Form C-103
May 27, 2004

WELL API NO. 30-041-10045
5. Indicate Type of Lease STATE <input checked="" type="checkbox"/> FEE <input checked="" type="checkbox"/>
6. State Oil & Gas Lease No. LC 060978
7. Lease Name or Unit Agreement Name: Milesand Unit
8. Well No. 135
9. OGRID Number
10. Pool name or Wildcat Milnesand (San Andres)

Proposed Plug and Abandon Operation

Proposed P&A - Milnesand Unit #135

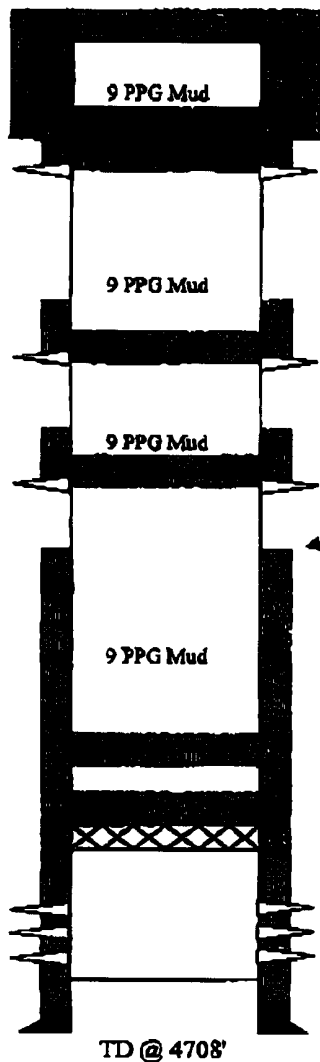
Plug #1: CIBP set @ 4525 set in 1981. Dump 3 sx cement on existing plug.
~~Plug #2: Pump 20 Sx cement plug @ 4125 to 4025. (Tag) Plug NOT REQUIRED~~
Plug #3: Perforate @ 2750'. Set pkr @ 2650 & squeeze 80 sx cement plug from 2650-2750'. (Tag)
Plug #4: Perforate @ 2250'. Set packer @ 2150' & squeeze 80 sx plug from 2150' to 2250'. (Tag)
Plug #5: Perforate @ 455'. Set packer @ 355' & squeeze backside with 150 sx. (Tag)
Plug #6: Pump 10 Sx surface Plug
Install Dry Hole Marker
